CITY OF BATON ROUGE
PARISH OF EAST BATON ROUGE
DEPARTMENT OF PUBLIC WORKS
SEWER ENGINEERING DIVISION

ADDENDUM NO. 3

SUBJECT: MULTIPLE PUMP STATIONS (HIGHWAY 61 – PLANK ROAD)
CITY-PARISH PROJECT NO. 11-PS-MS-0035

BIO-DAN CONTROL SYSTEM: P & ID BIOSCRUBBER

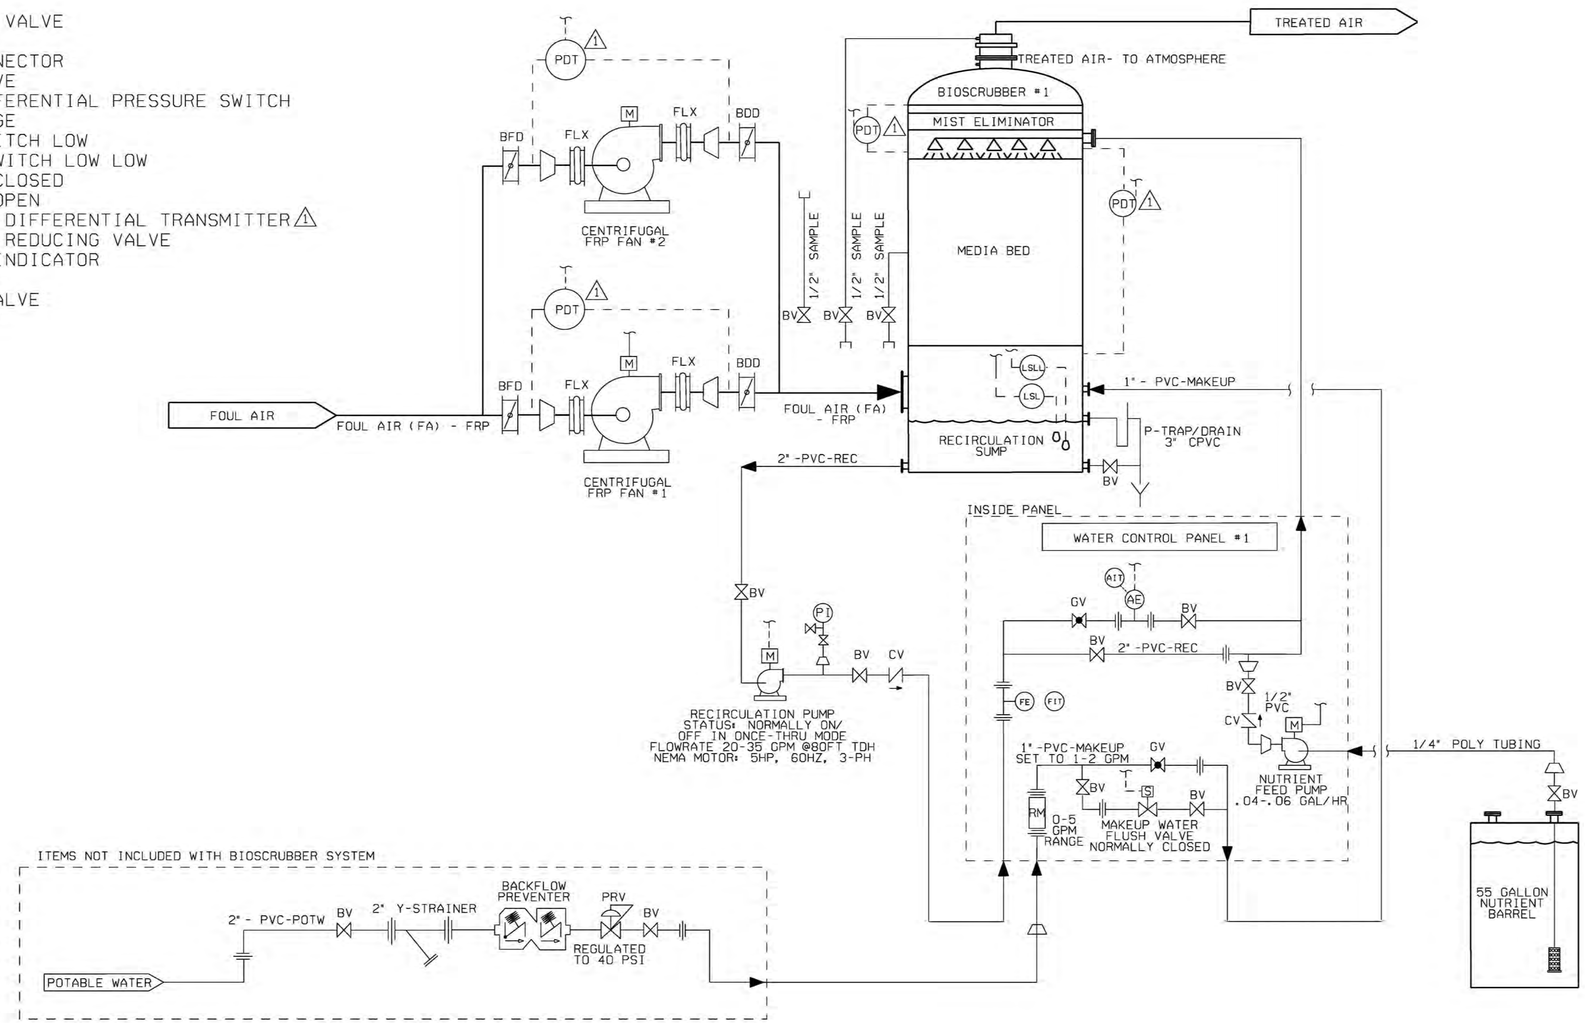
2. Similarly, in the P&ID drawing (Sheet No. 43-OC003). A differential pressure indicator is shown measuring the differential pressure across the blowers. However, within the Bioscrubber Odor Control System spec Section 20.9 F.8, the spec calls out that the fans need to have a low and high differential pressure set point. This is confusing because in order to have set points you would need to install a differential pressure transmitter, or pressure switches to trip the set points rather than just an indicator.

Please clarify if the intent is to have a differential pressure gauge, switches or transmitters across the blowers.

SHT.	105-C02R
PARISH	EAST BATON ROUGE
CITY	BATON ROUGE
PROJECT	11-PS-MS-0035
DESIGNED	J. KLIER
CHECKED	J. RICHARDSON
DETAILED	D. SMITH
CHECKED	D. ROSHTO
DATE	MARCH 2016
SHEET	
BY	J.M.K.

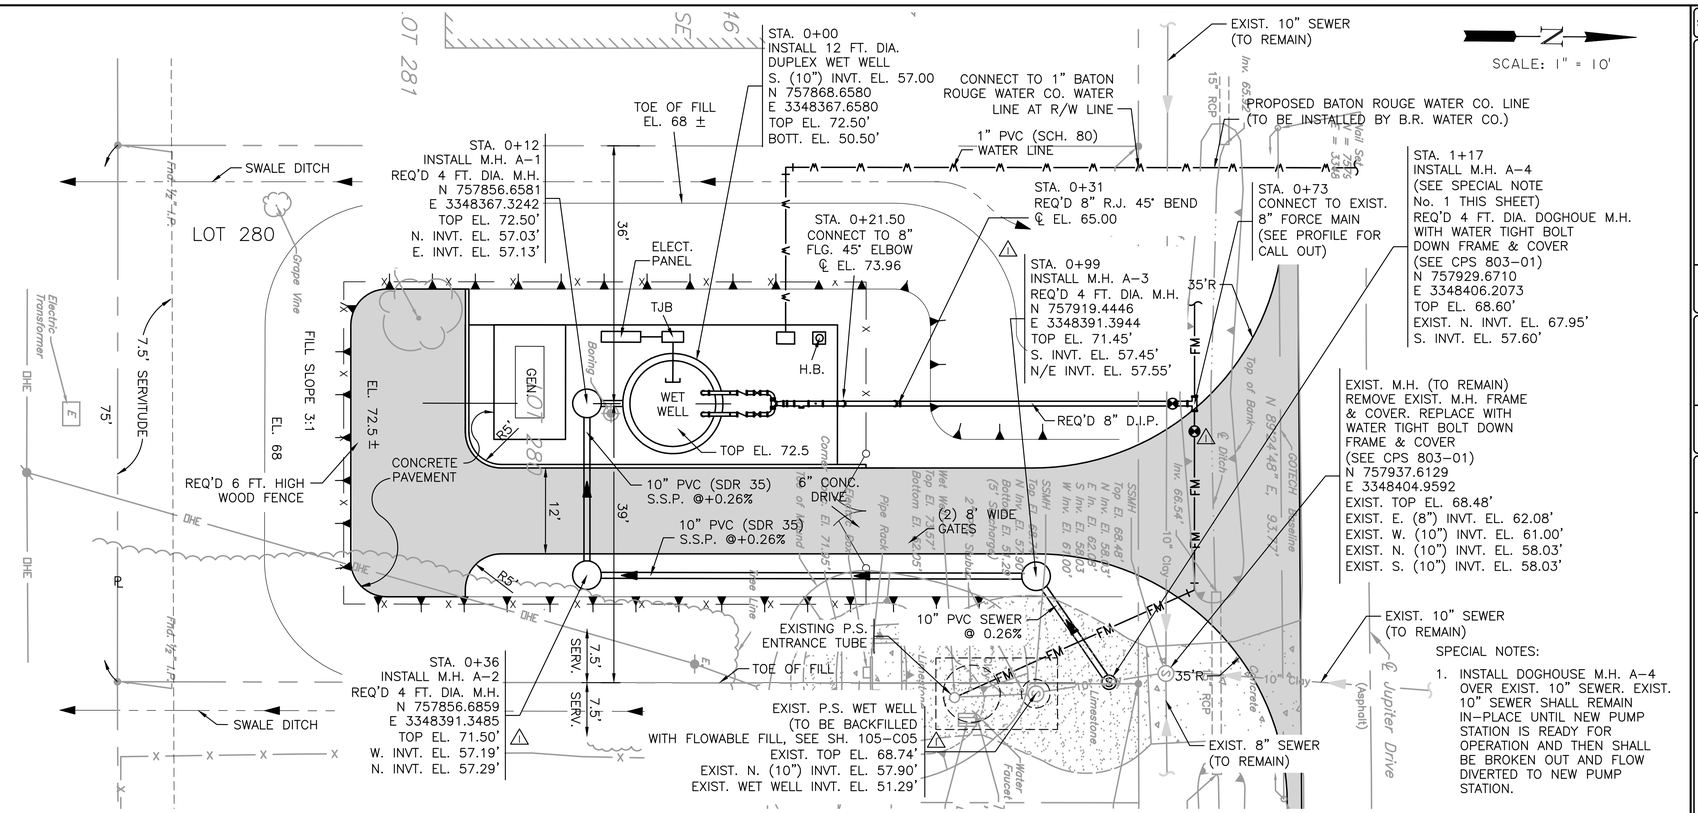
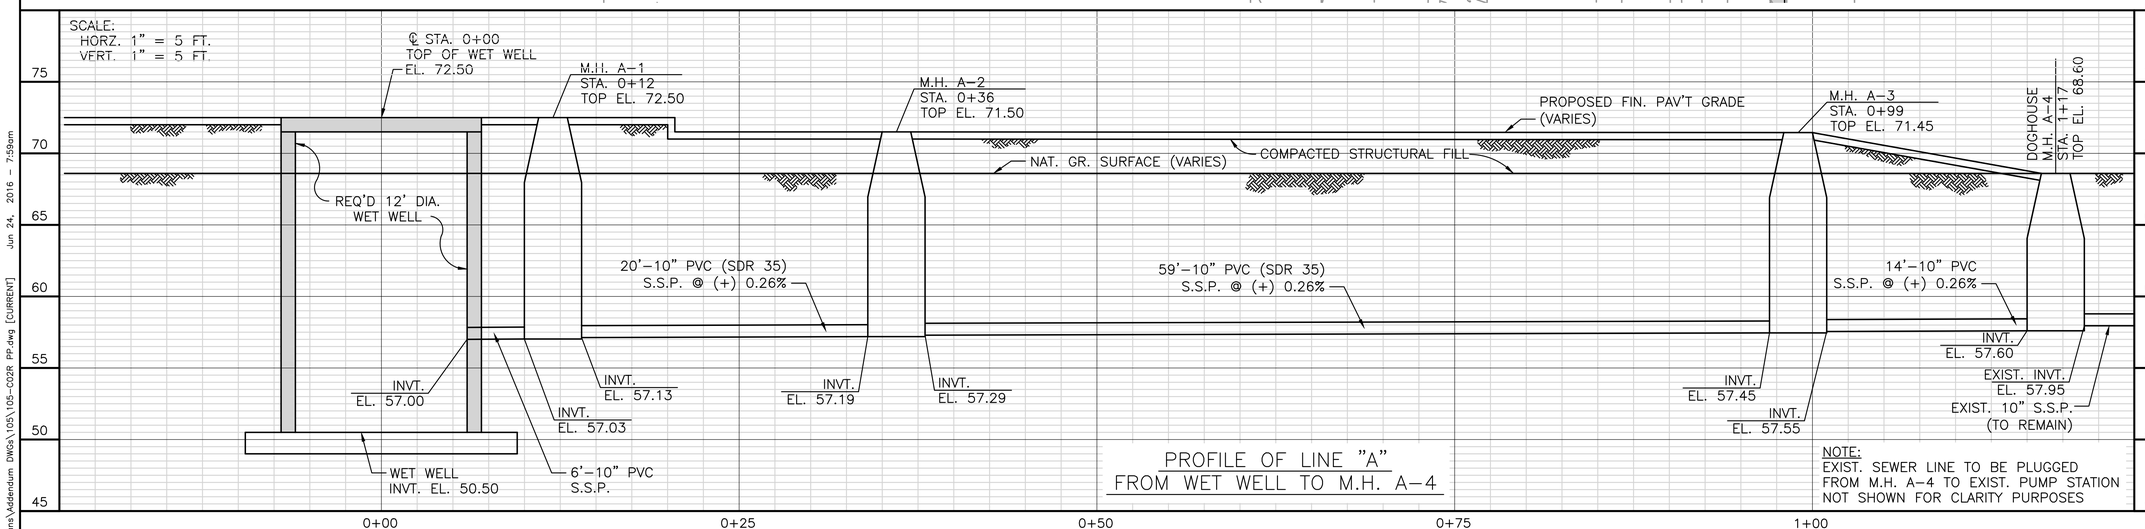
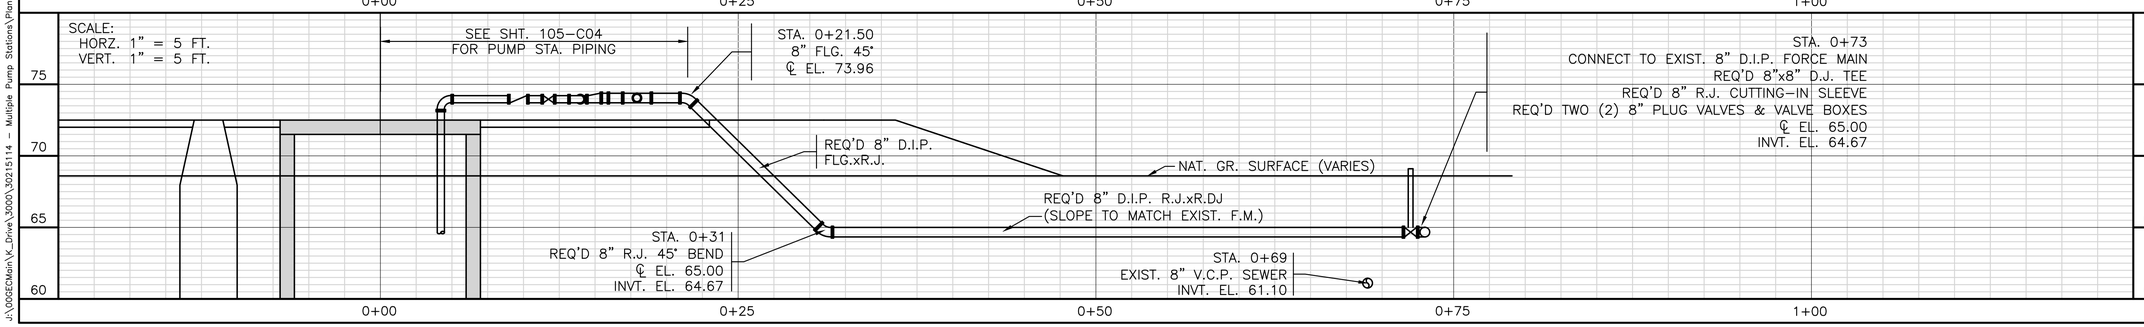
6. Sheets 105-CO2 and 105-CO3 show different slopes and elevations for the fill area, which sheet should be accepted as correct?

20. On Sheet 105-C02, the 8" new Force Main is tying into the existing force main without stopping flow back to the existing Pump Station. Should there be an additional Plug valve on the existing Pump Station side or are we just to put the plug valve shown on the existing line on the pump station side of the tie-in?

See Sheet Nos. 105-C02R and 105-C03R, attached to this addendum.

Yes, see Sheet No. 105-C02R, attached to this Addendum.

SHT.	124-C02R
PARISH	EAST BATON ROUGE
CITY	BATON ROUGE
PROJECT	11-PS-MS-0035
DESIGNED	J. KLIER
CHECKED	J. RICHARDSON
DETAILED	D. SMITH
CHECKED	D. ROSHTO
DATE	MARCH 2016
SHEET

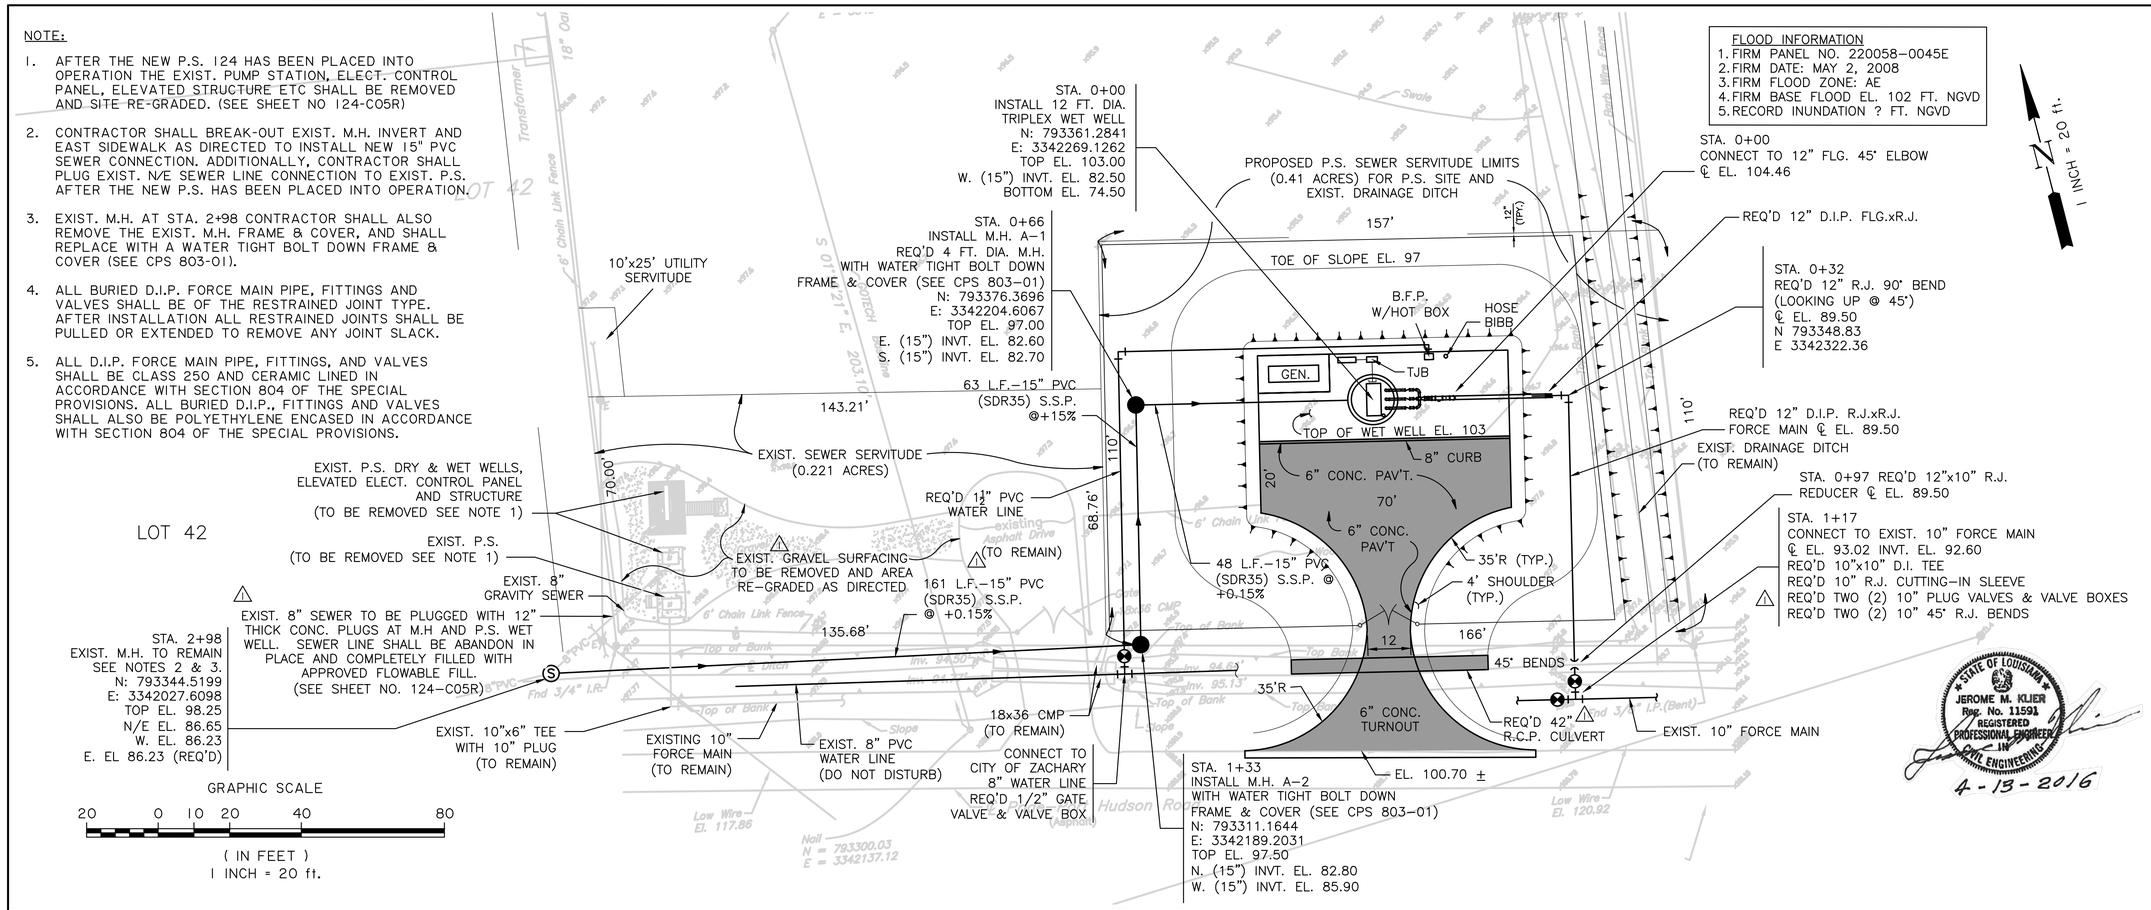
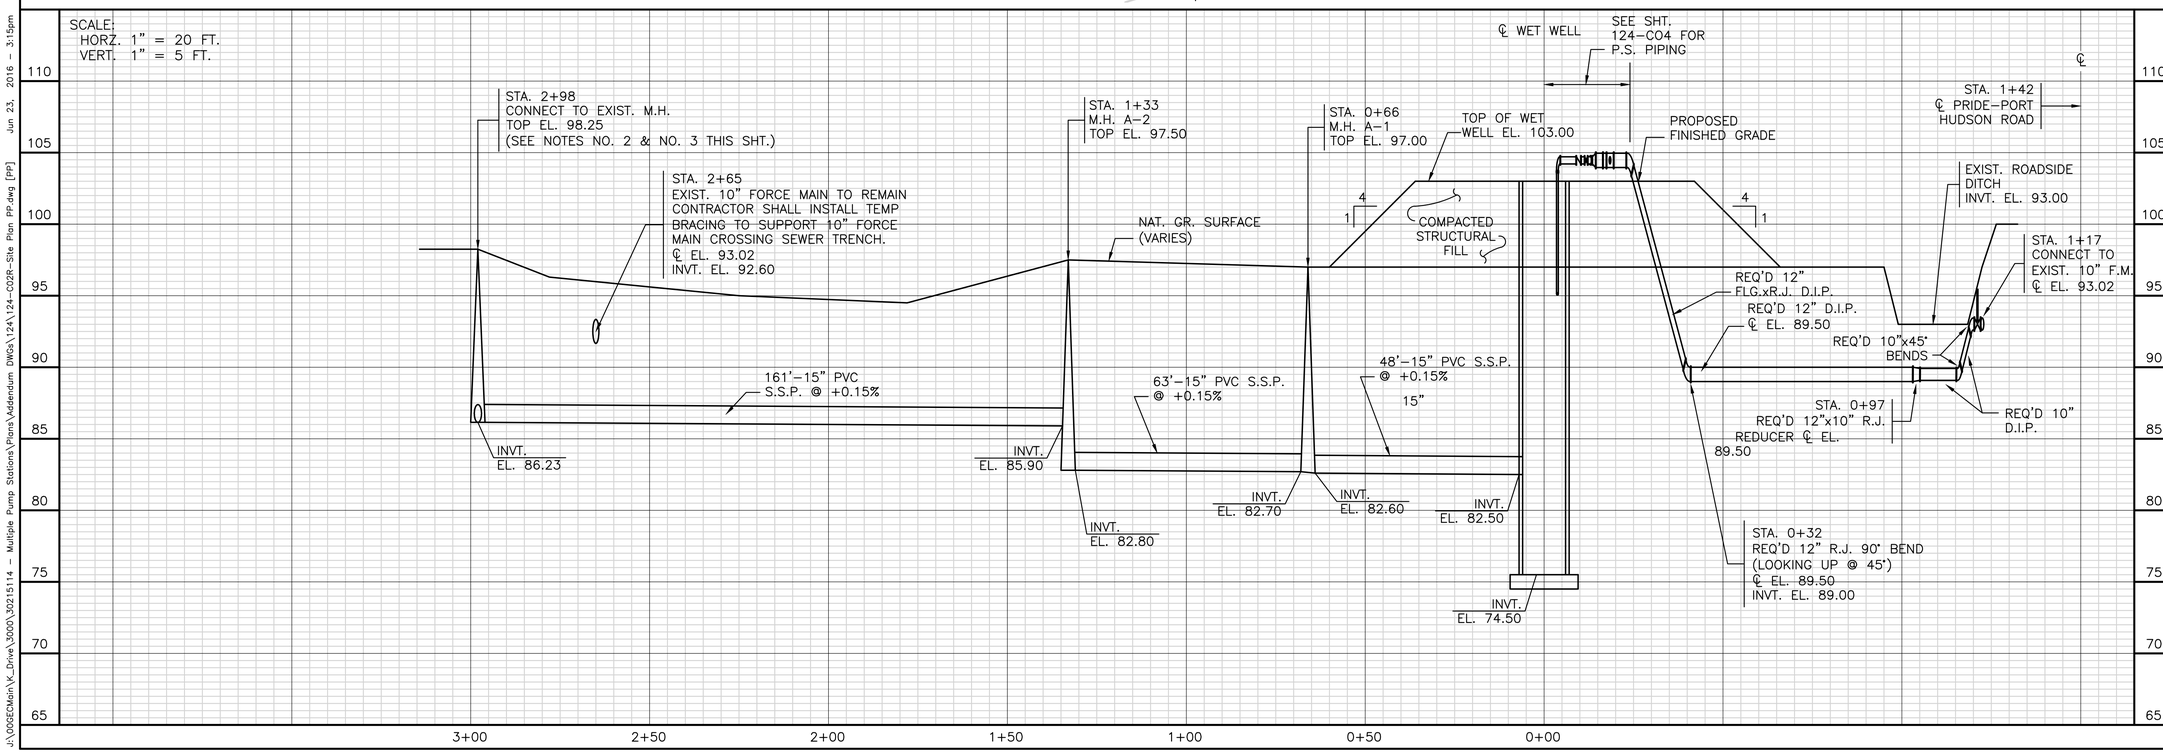
22. Drawing 124-C02 plan and profile calls out the wet well invert at EL. 74.5. Drawing 124-S01 shows the invert at EL. 77.5. Please clarify.

The required invert elevation is 74.5. See Sheet No. 124-S01R, attached to this addendum.
